# PRODUCT / PROCESS CHANGE NOTIFICATION

# ST Shenzhen (China) Assy & Test line upgrade for Automotive grade EEPROM products in SO8N

### Bottom side views

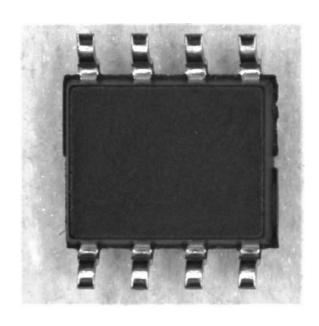
A visual difference can be observed at bottom side: the **package of the SHD line** is showing a **dot at the center** while no dot at bottom side on the package of the HD line:

Top side views

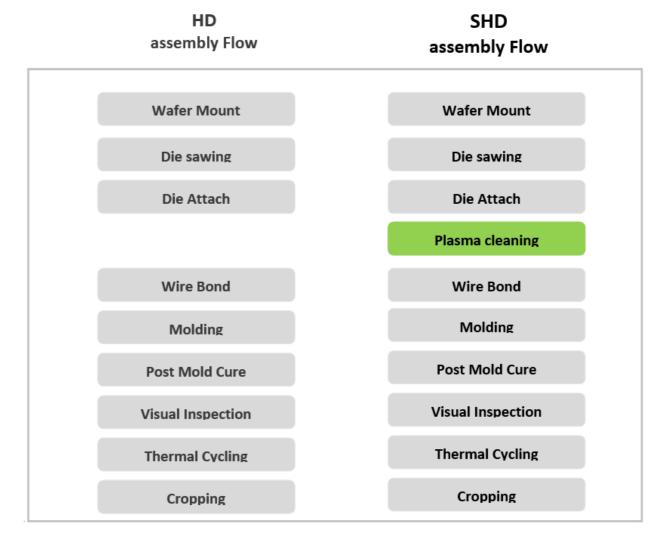
#### **Marking readability improvement:**
